Czech Sport Aircraft a.s.	<b>SERVICE BULLETIN</b>	Czech Sport Aircraft a.s. Na Záhonech 212, 686 04 Kunovice Czech Republic office@czechsportaircraft.com
No. SB-CR-032		Rev.: -
Date: 2015-10-23		
Page: 1 of 13		Date: -

<b>MODEL AFFECTED:</b>	PS-28 Cruiser / SportCruiser / PiperSport
<b>SUBJECT:</b>	Reinforcement of the nose wheel leg attachment to the firewall
<b>AIRCRAFT AFFECTED:</b>	All PS-28 Cruiser, SportCruiser, PiperSport aircraft equipped with or being in process of installation of the new NLG leg – dwg. SG0300N.
<b>COMPLIANCE:</b>	Apply this Service Bulletin not later than at the next scheduled inspection after 50 flight hours (see the CR-MM-1-0-00, Rev.13, Chapter 2, point 2.5.1.e) or promptly after issue of this Bulletin in case that local cracks and/or deformation of vertical brackets on the nose landing gear leg attachment to the firewall are discovered, or upon installation of a new NLG leg – dwg. SG0300N.

This Service Bulletin contains instructions for installation of parts for reinforcement of the nose landing gear leg attachment to the firewall.

Scheme No.1 – Parts on the Firewall to be checked for possible local cracks, deflection or deformation

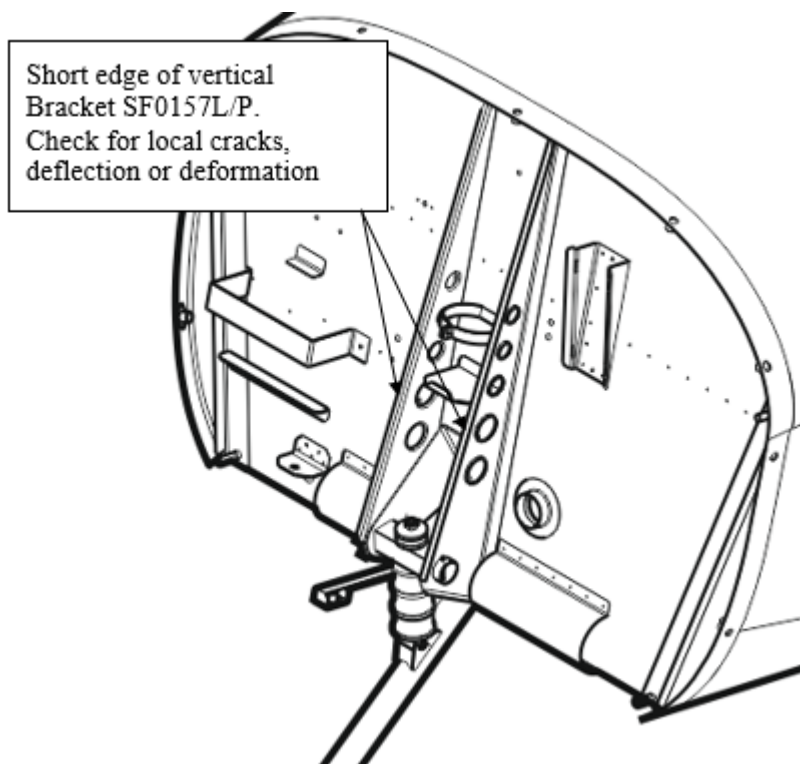
Minor local cracks and deformations of the SF0157L/P vertical brackets short edge in the nose landing gear leg attachment to the firewall were discovered on some PS-28 Cruiser aircraft. To avoid a possible occurrence of this situation a set of parts to increase the carrying capacity of the SF0157L/P vertical brackets by means of SF0602L/P stiffener, SF0604/N bulkhead and SF0601L/P "U" stiffener has been developed.

For places to check, see the Scheme No.1.

**Supplement No. 1:** Assembly - Reinforcement of the nose wheel leg attachment on the firewall  
- Sheet 1

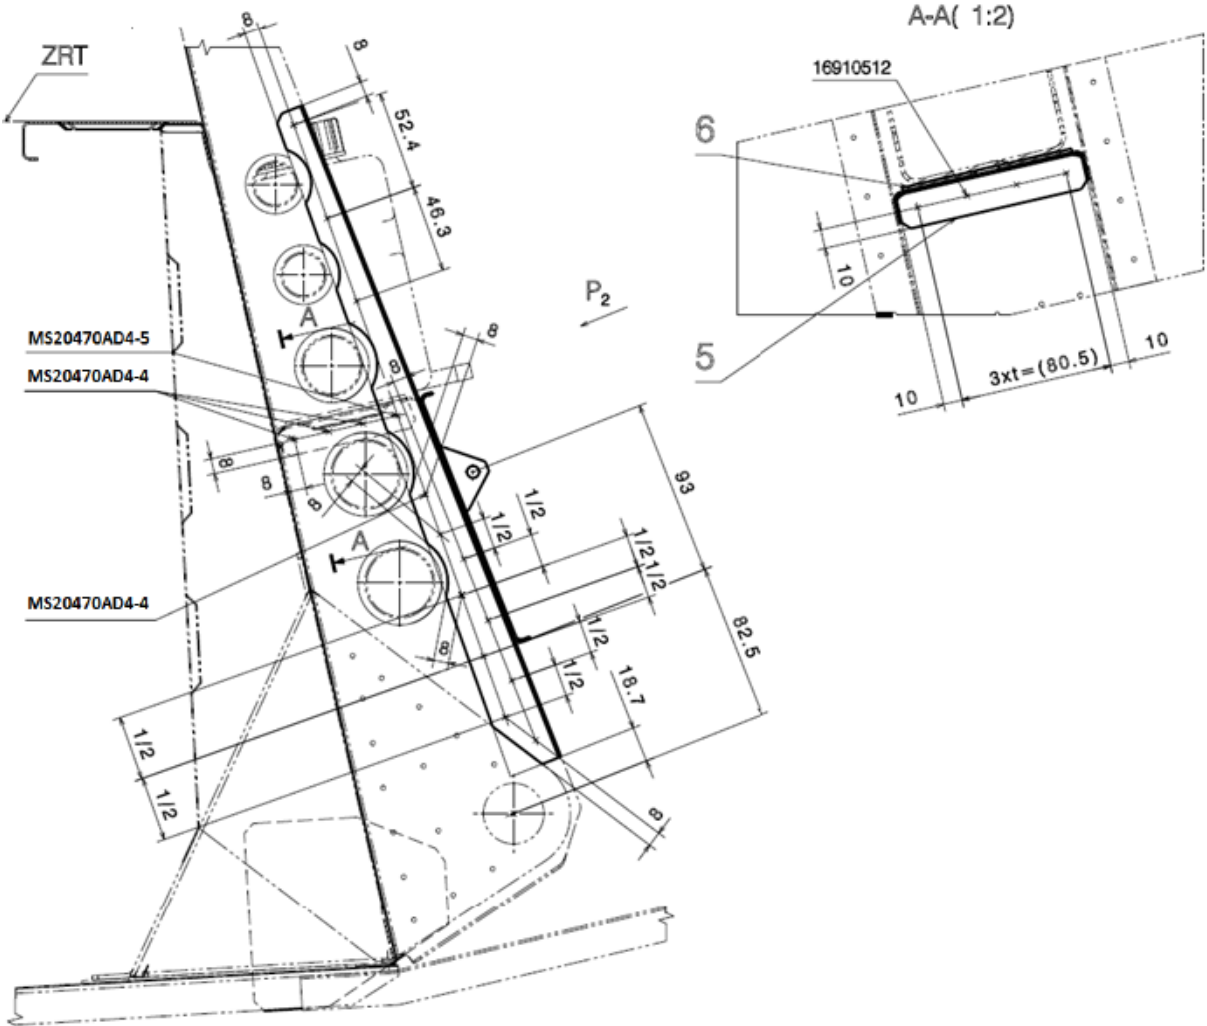
8. Fit the **Stiffener SF0602P** in place with the **Bracket SF0157P** in accordance with the scheme in the Supplement No.1 and drill together. Use drill bit of dia.2,4 mm. Use Agrafs to hold together, see the Pictures 3, 4 in the Supplement No.4.

9. Fit the **Stiffener SF0602L** in place with the **Bracket SF0157L** in accordance with the scheme in the Supplement No.1 and drill together. Use drill bit of dia.2,4 mm. Use Agrafs to hold together

11. Use the **Cork Plate SF0605N** and stick it to the **Bulkhead SF0604N**. Use the Chemopren Pattex or similar glue to stick.
12. Take the **Bulkhead SF0604N & Cork Plate assembly**, then fit the assembly in place with the **Brackets SF0157L/P** in accordance with the scheme in the Supplement No.1 and drill together with the Brackets. Use the drill bit of dia.2,4 mm for holes. Use Agrafs to hold together. See the Pictures 5, 6 in the Supplement No.4.

**Note:** *The bottom part of the Bulkhead SF0604N which is connected to the Firewall is riveted by Blind rivets, see the Supplement No.1, Section A-A.*

**Supplement No. 2:** Assembly - Reinforcement of the nose wheel leg attachment on the firewall  
– Sheet 2

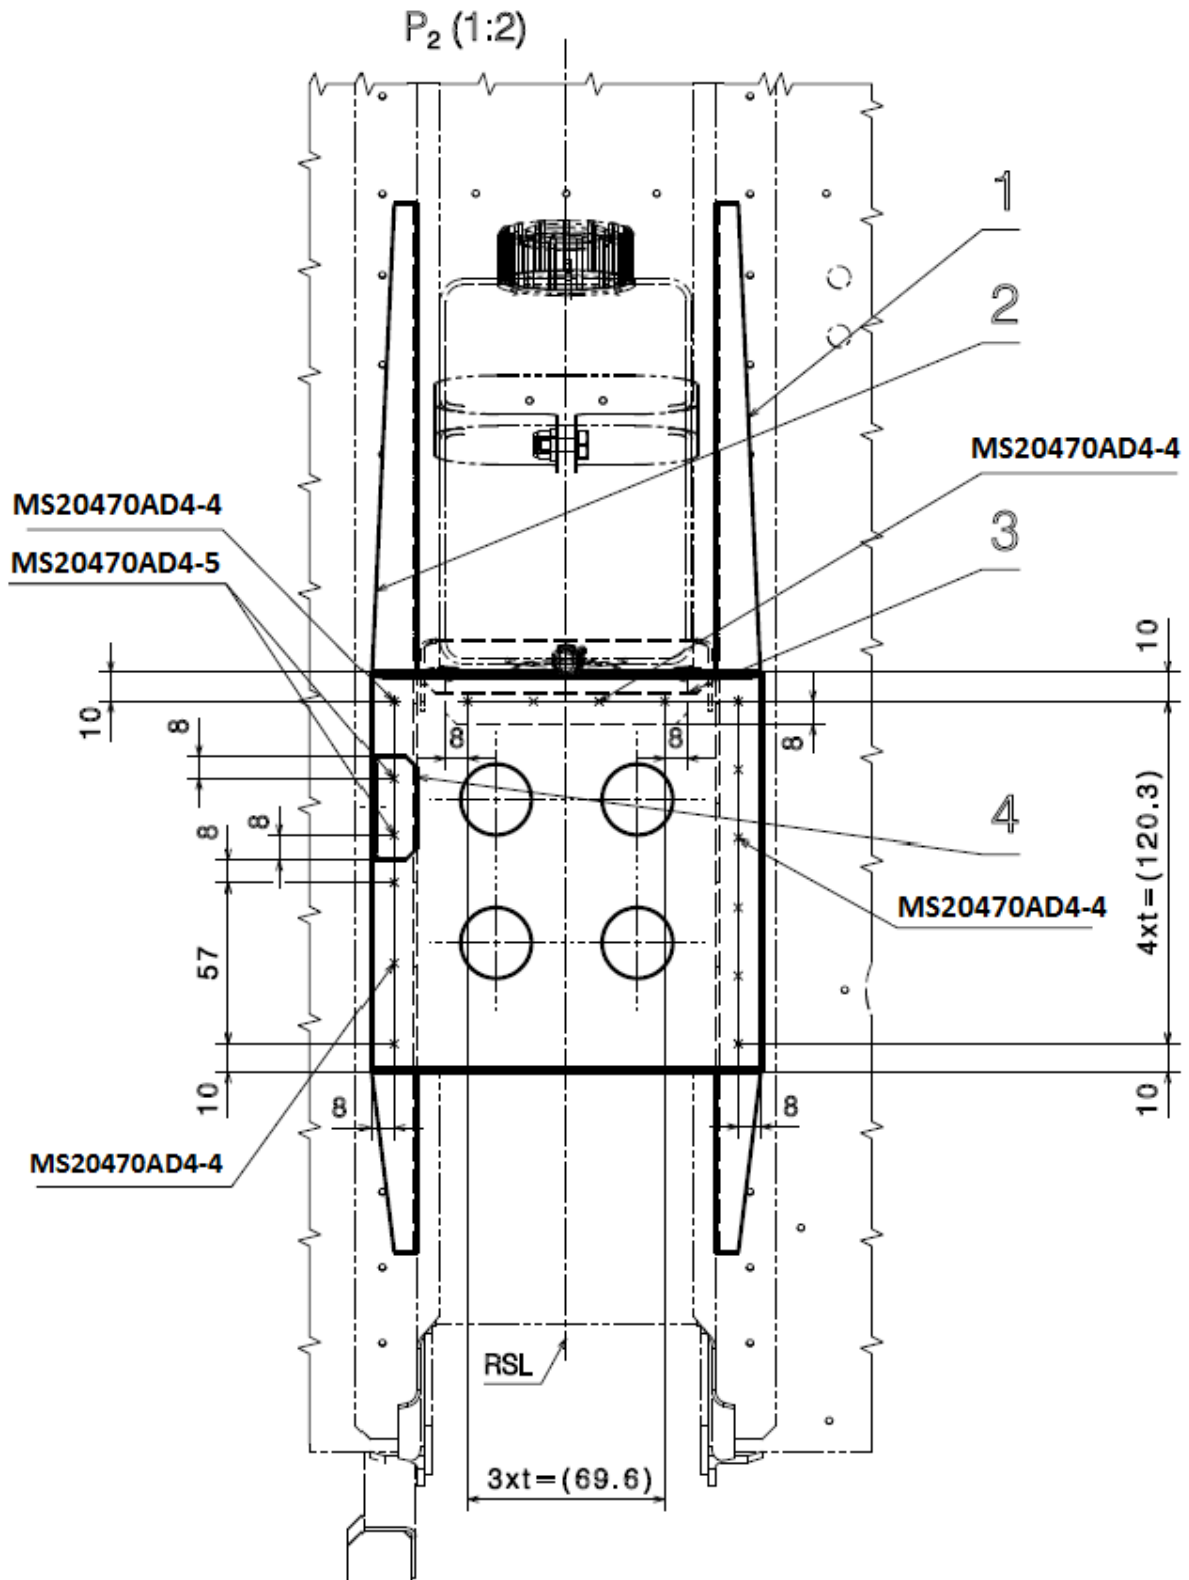
14. Use the **Valve Console SF0603N**, fit it in place with the **“U” Stiffener SF0601N** accordingly to the scheme in the Supplement No.1 and No.2 and drill (2,4 mm) together. Use Agrafs to hold together. See the Pictures 7, 8 in the Supplement No.4.

17. Rivet the parts. For details, see the Pictures 5, 6 in the Supplement No.4. For individual parts use the rivets in accordance with the table in the Supplement No.3. The rivet type is defined in scheme in the Supplements No.1 and No.2.

Picture 7

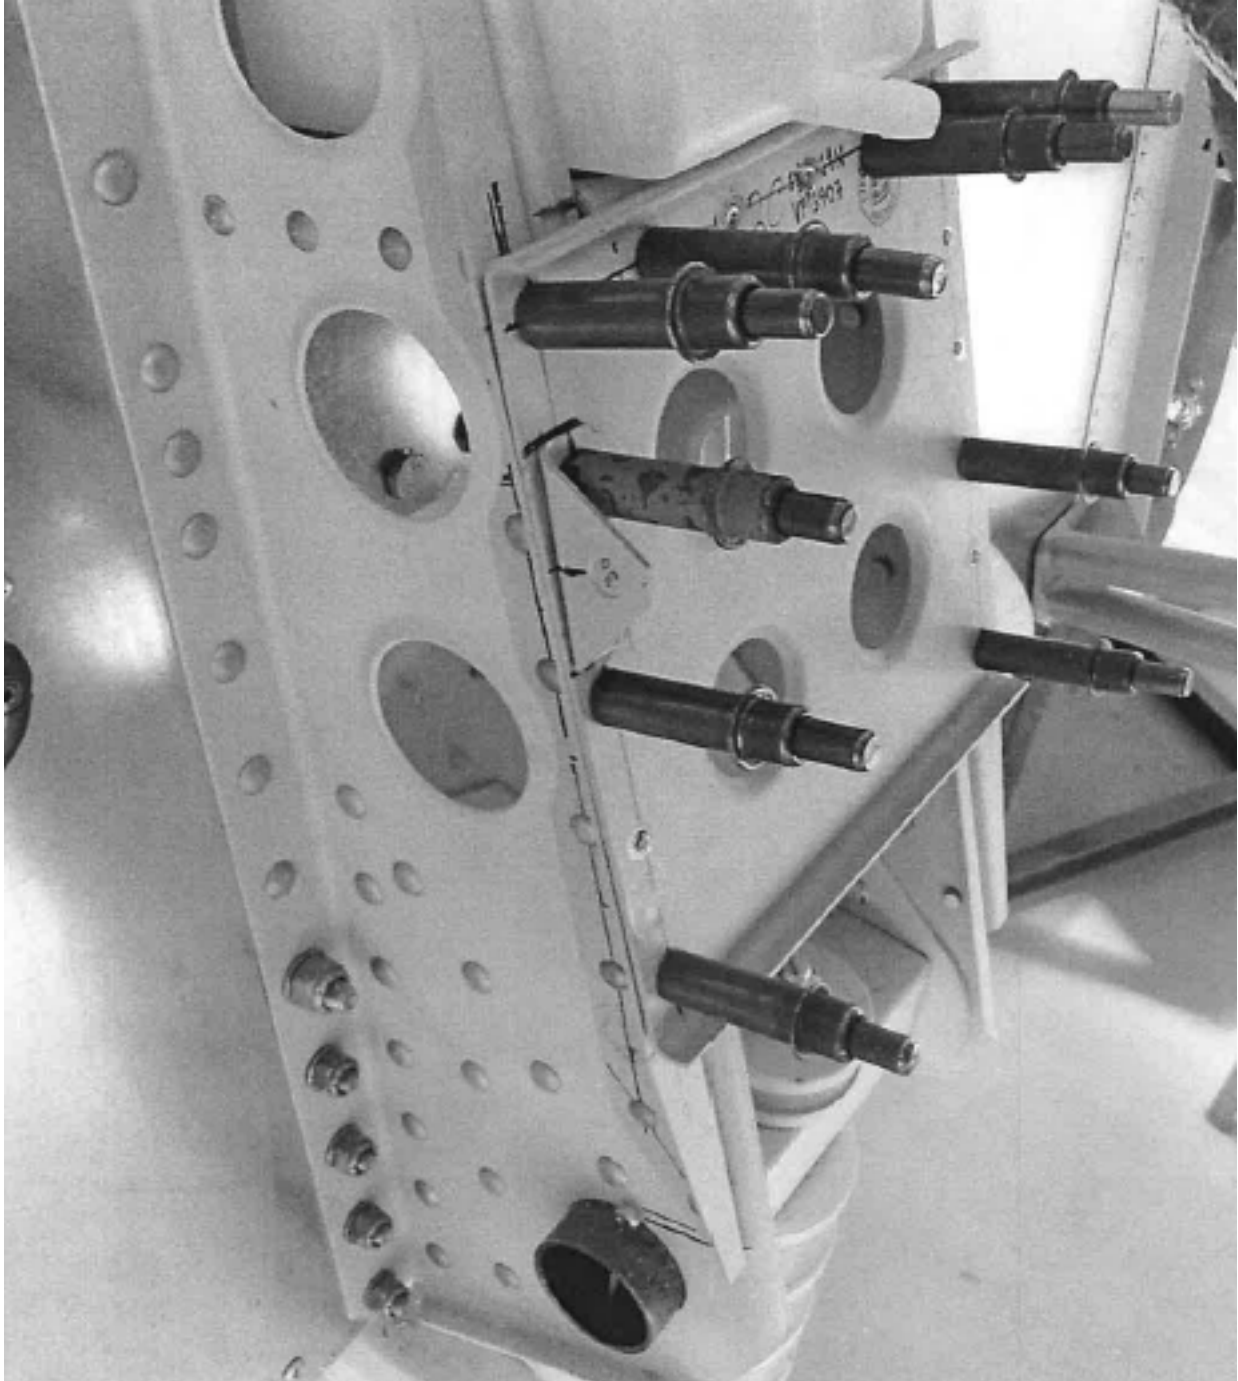
18. Fit the **“U” Stiffener SF0601N** in place, hold together with Agrafs and rivet. See the Pictures 7 to 10 in the Supplement No.4.  
**Note:** *If not enough space to rivet the top rivet row of the “U” Stiffener SF0601N, then first hold it with Agrafs in the upper rivet row only and lift up the bottom part of the “U” Stiffener. Insert hand with a suitable bucking bar under the Stiffener and apply riveting of the top rivet row. As late as the top row is riveted continue and rivet the further rows.*
